RE: Response to Submissions – PA2024/0392
At: Lot 03981 Town of Darwin (17 Harry Chan Avenue, Darwin City)

1.0 Further Information

Via request dated 16 January 2025, Development Assessment Services requested further information to enable assessment of the application to continue. The amended plan set attached hereto addresses the architectural components of the requested further information / clarification. The request items are included in italics below, with the applicant's response to each item contained immediately thereafter.

WATERPROOFING TREATMENT ABOVE HABITABLE SPACE

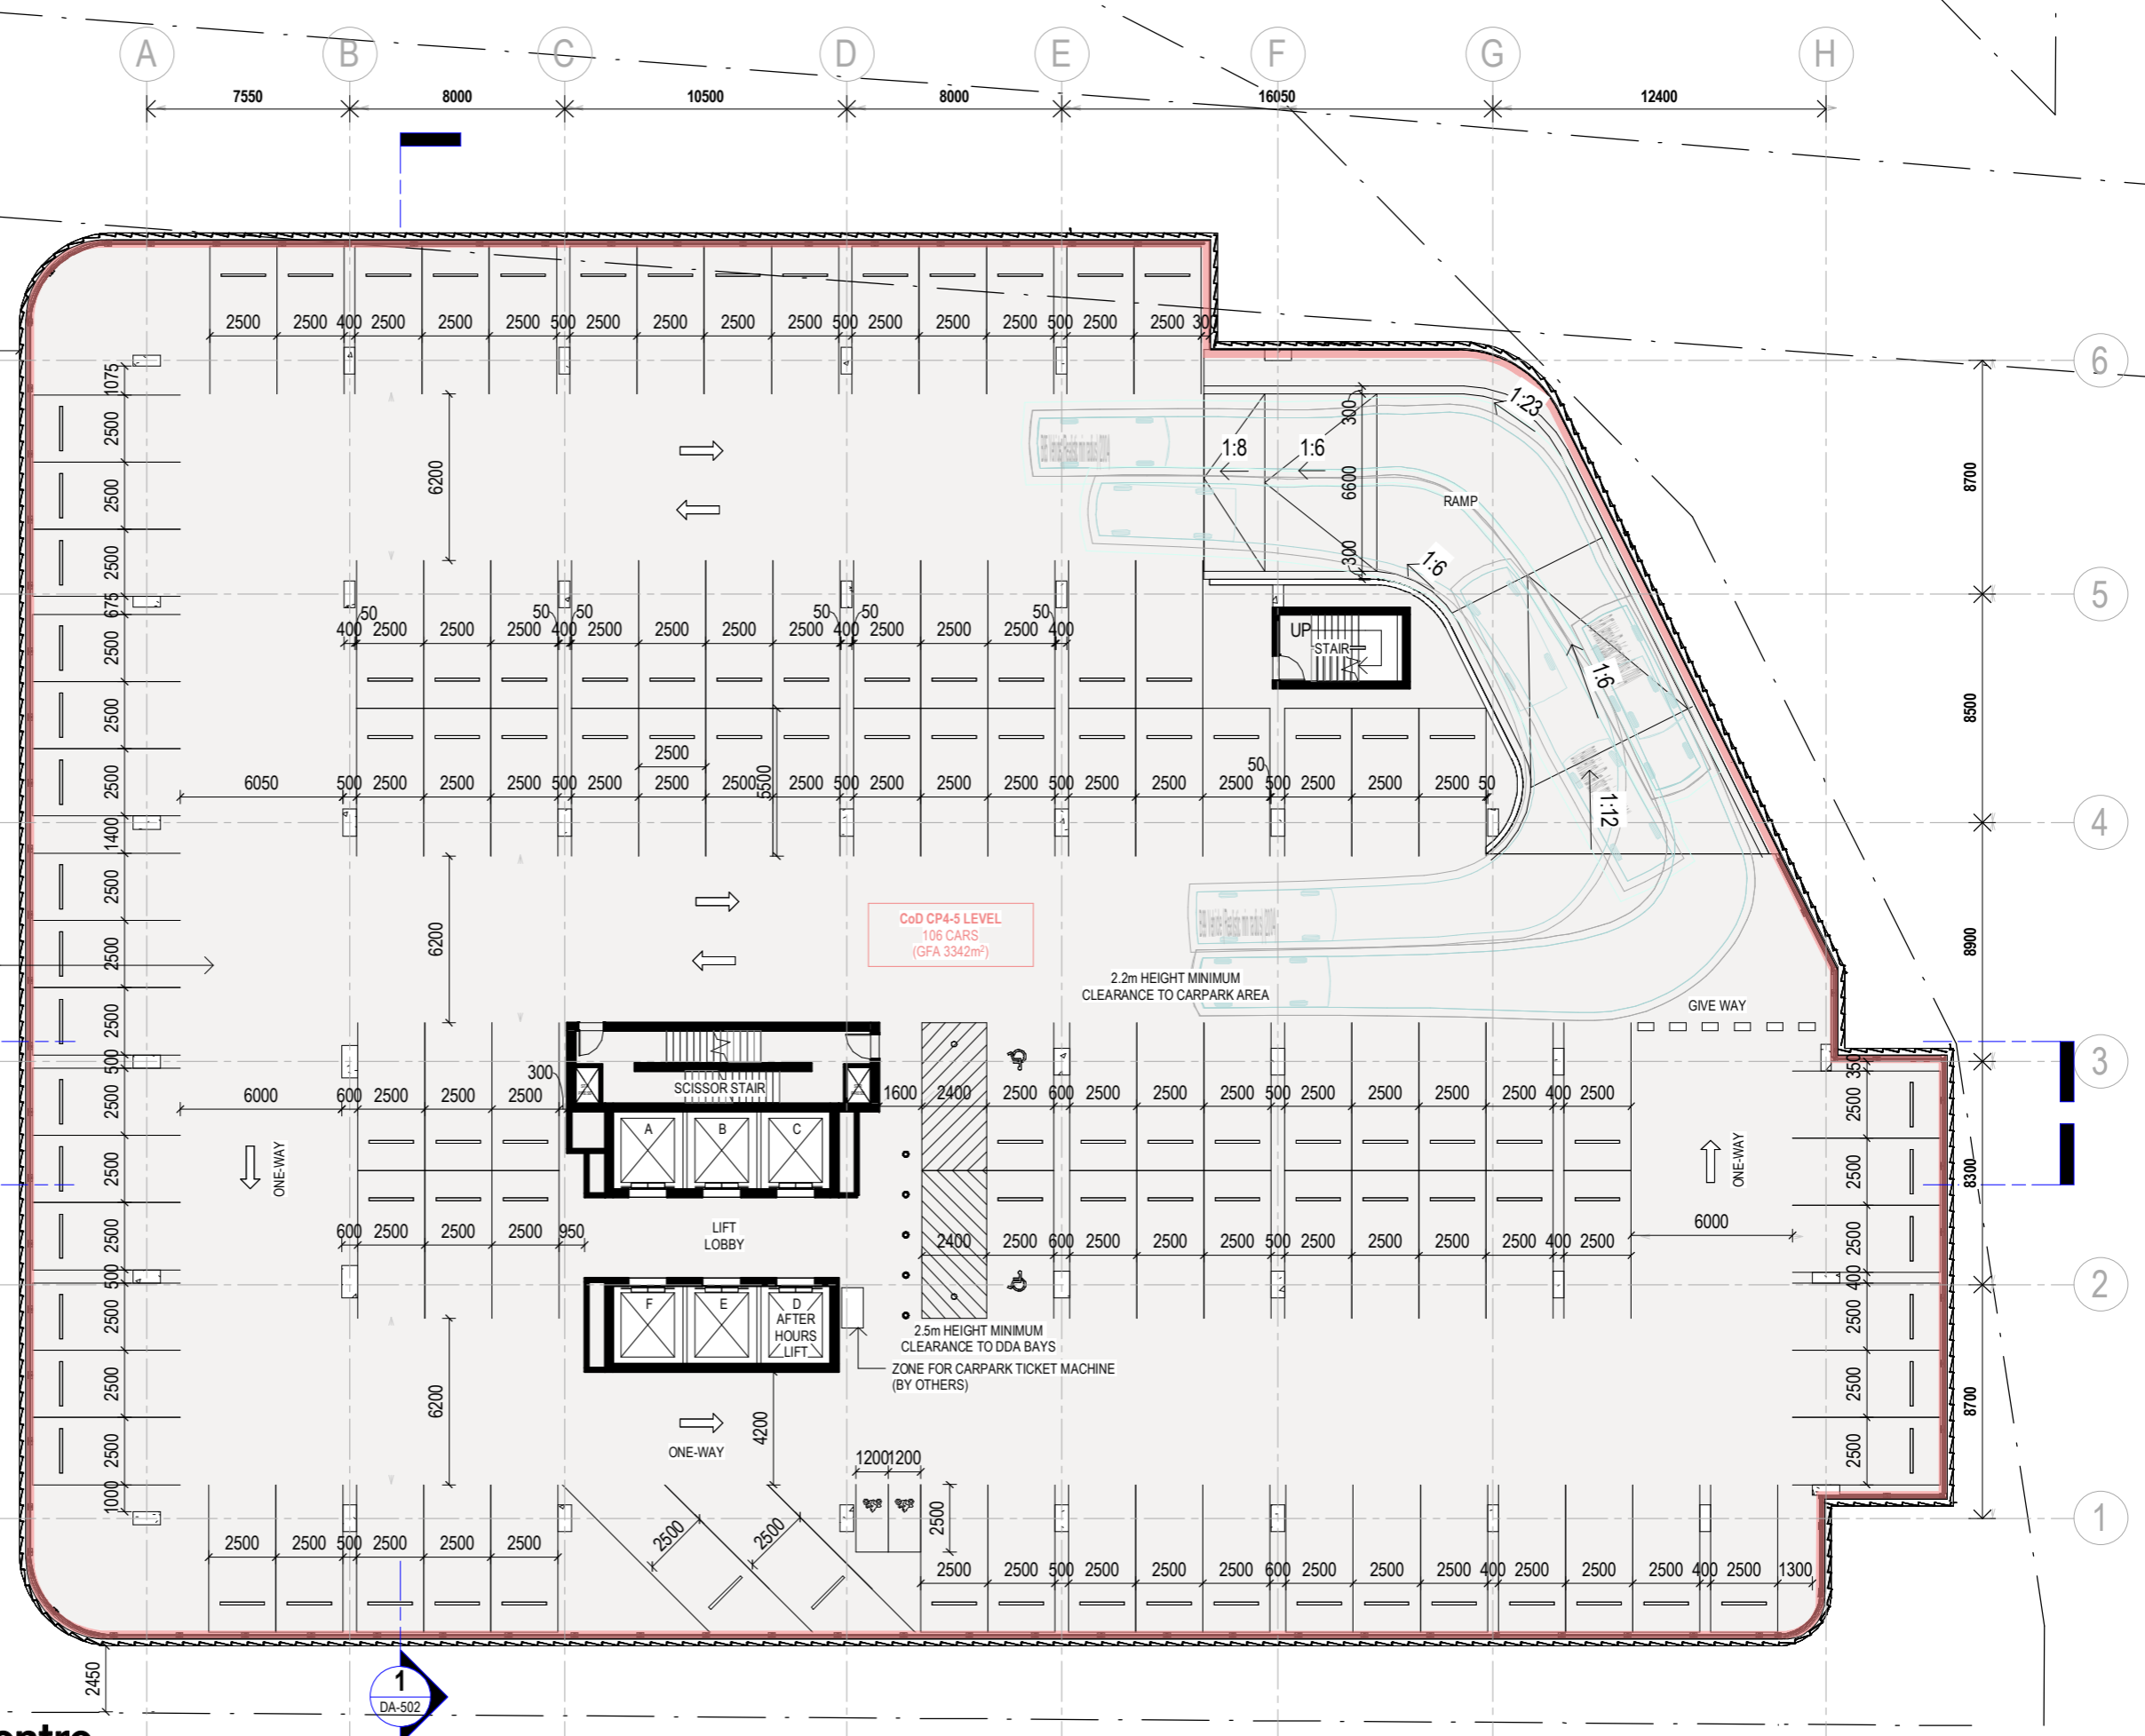
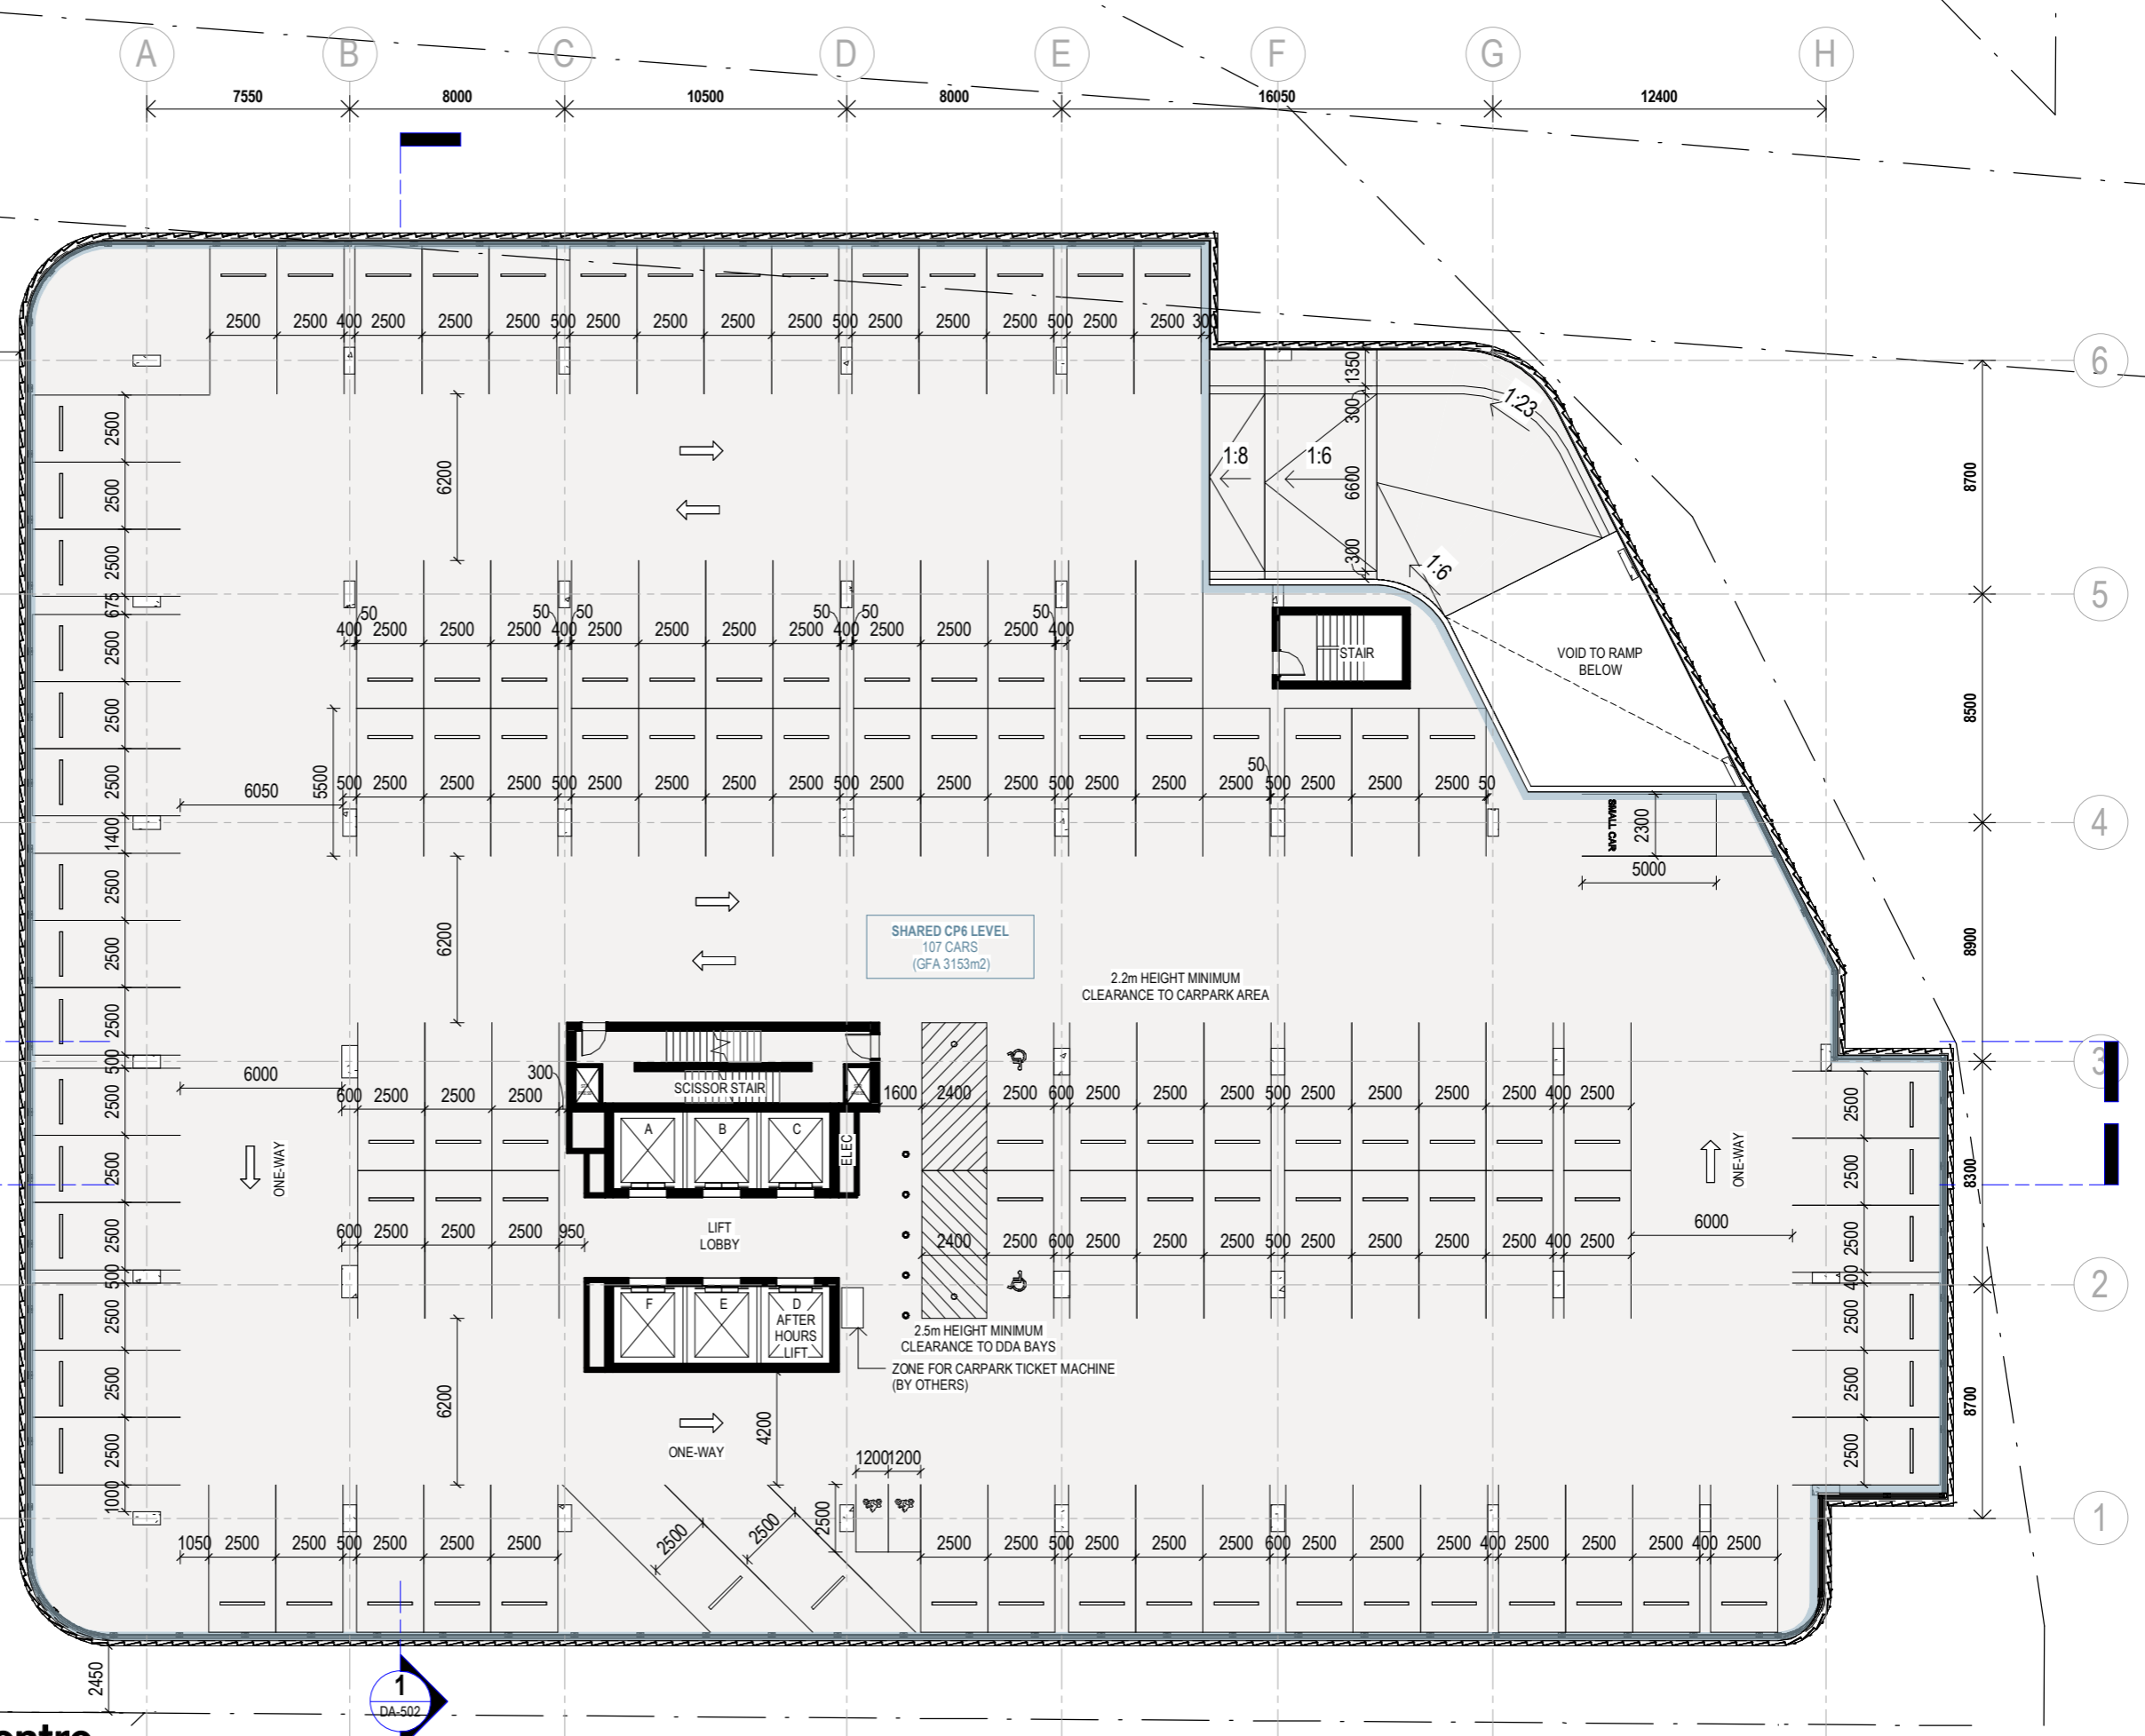
- *Update drawing DA-103 – DA – 106 to dimension the small car parking spaces and to clarify if the column encroaches into the southern corner car parking space at all levels. Can be addressed via permit conditions.*

The car parking table on DA-103 – 106 indicates the dimensions of the 2 proposed small car parking spaces (2.3m x 5.4m and 2.3m x 5.0m). Drawings have been updated to confirm that the columns do not encroach into the car parking spaces.
